Subject: Camden Harbor SHIP Grant – HOIST PROCUREMENT
State WIN: 018534.12
Amendment No. 2

This amendment includes changes to the Bid Documents and questions /RFIs received and responses.

**ADDENDUM NO. 2
MAY 7, 2015**

**CAMDEN PUBLIC LANDING
IMPROVEMENTS**

RECEPTACLE MOUNTING DETAIL

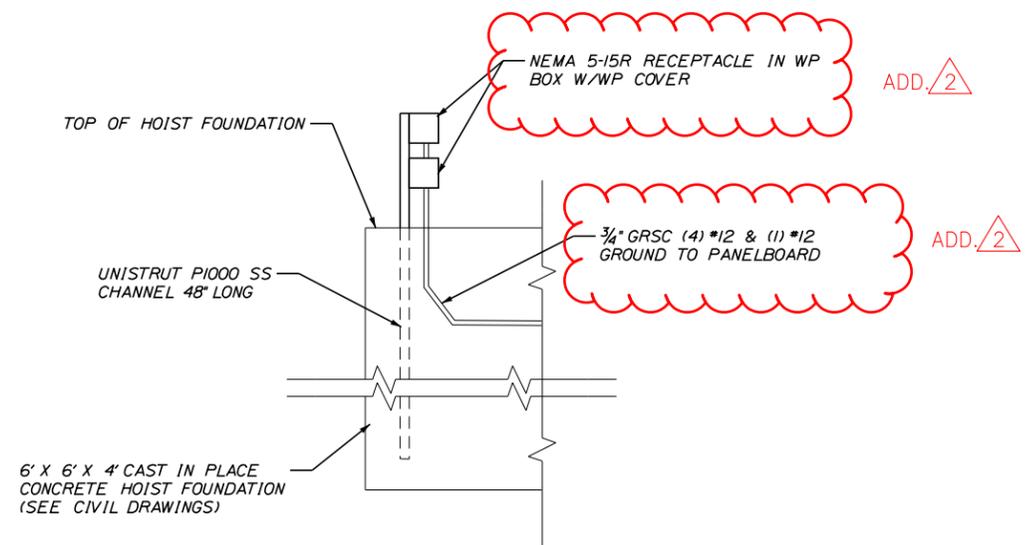
ADD. 2

HOIST AREA DETAIL

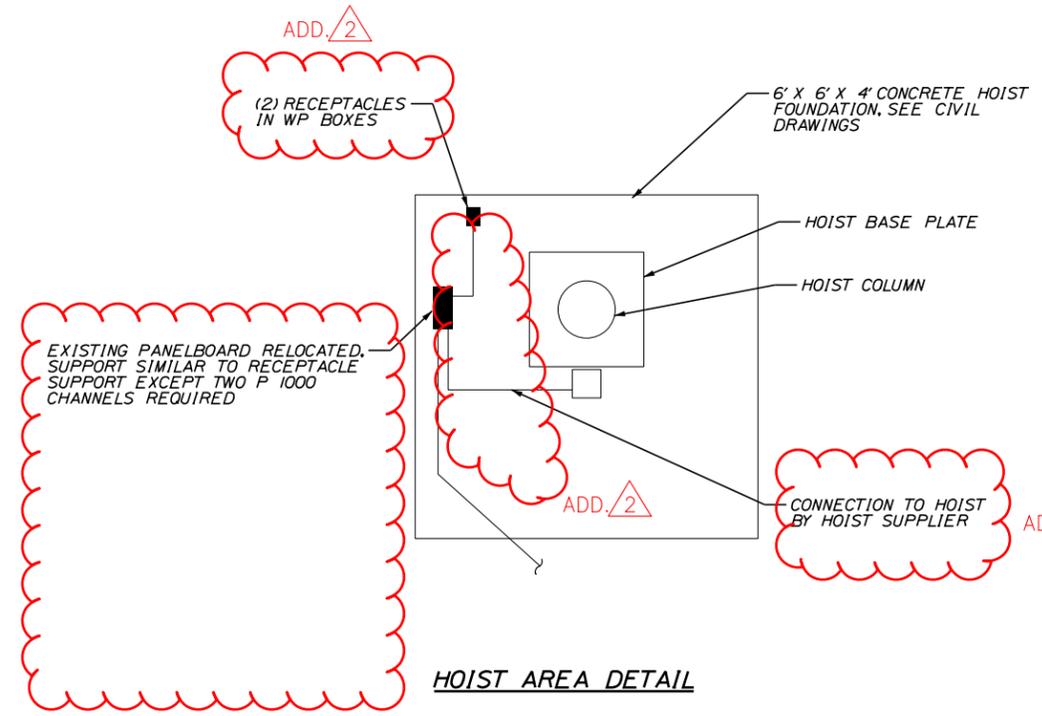
ADD. 2

ADD. 2
